Access Compliance Report

Public Rights-of-Way (Curb Ramps)

| Intersection ID: 4810 | Main Street: BEN_CRAIG_DR | Cross Street: MALLARD_CREEK_RD | Location: W |
| ADA ID: 8A08941769C9 | Ramp Type: Perp | Initial Pass/Fail: Fail | Overall Compliance: No |

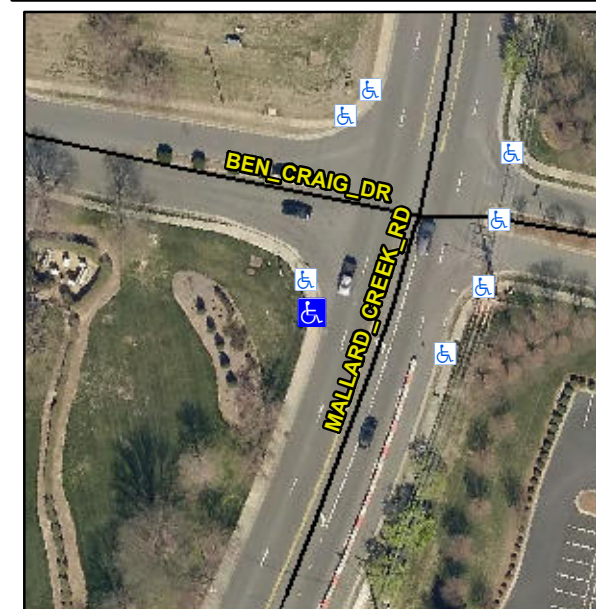
Not Found, R304.5.1, R304.2.2

| Compliance | Description | Data | Compliance | Description | Data |
|------------|-----------------------|-------|------------|-----------------------------|------|
| N/A | Ramp Length (in) | 61.5 | No | Ramp Slope (%) | 9.5 |
| No | Ramp Width (in) | 41.0 | Yes | Ramp XSlope (%) | 4.4 |

Remove & Replace Entire Ramp.
